Amendments to the Drawings:

Remarks:

Applic. No. 10/705,514
Response Dated July 9, 2007
Responsive to Office Action of March 8, 2007

Annotated Sheet

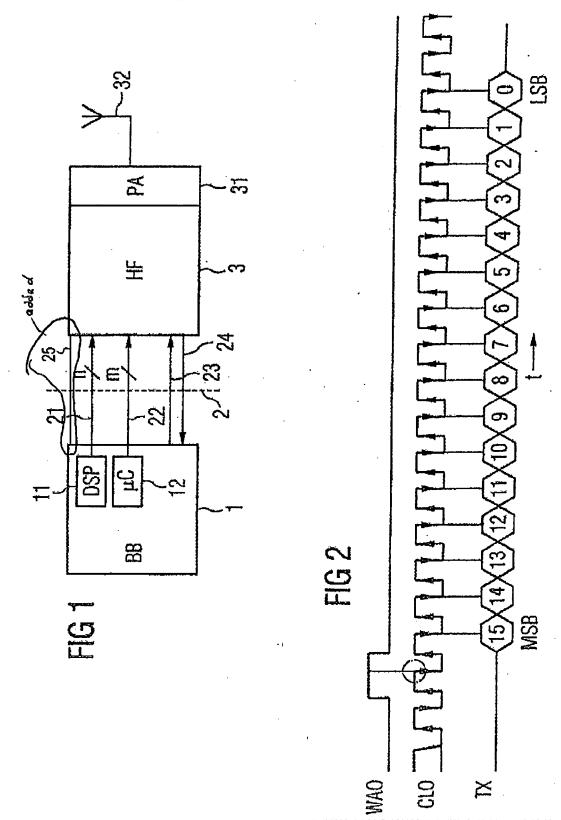
Fig. 1 has been amended to show a control line 25 extending from the baseband component to the radio-frequency component. A Replacement sheet and an annotated sheet showing the changes made are being included herewith. The amendment to the Fig. 1 is not believed to add new matter to the specification of the instant application.

In item 4 of the above-identified Office Action, the drawings were objected to as allegedly not showing every feature of the invention specified in the claims. More particularly, item 4 alleged that the drawings did not show "a data line for serial data transmission", "a bit clock line", "a word clock line", "a selection line" and "a control line for driving power amplifier". Applicants respectfully disagree.

Applicants have amended Fig. 1 to show a control line 25. As such, Applicants are appending hereto, a replacement sheet and an annotated sheet showing the change made to Fig. 1.

Additionally, the paragraph starting on page 17 of the instant application, line 9, has been amended herein to reflect the amendment to the drawings. The amendments to Fig. 1, as well as the amendments to page 17 of the specification, are supported by the specification of the instant application, as

In a further preferred embodiment of the present invention, an additional control line for driving a power amplifier for amplification of the radio-frequency signal is provided between the baseband component and the radio-frequency component.
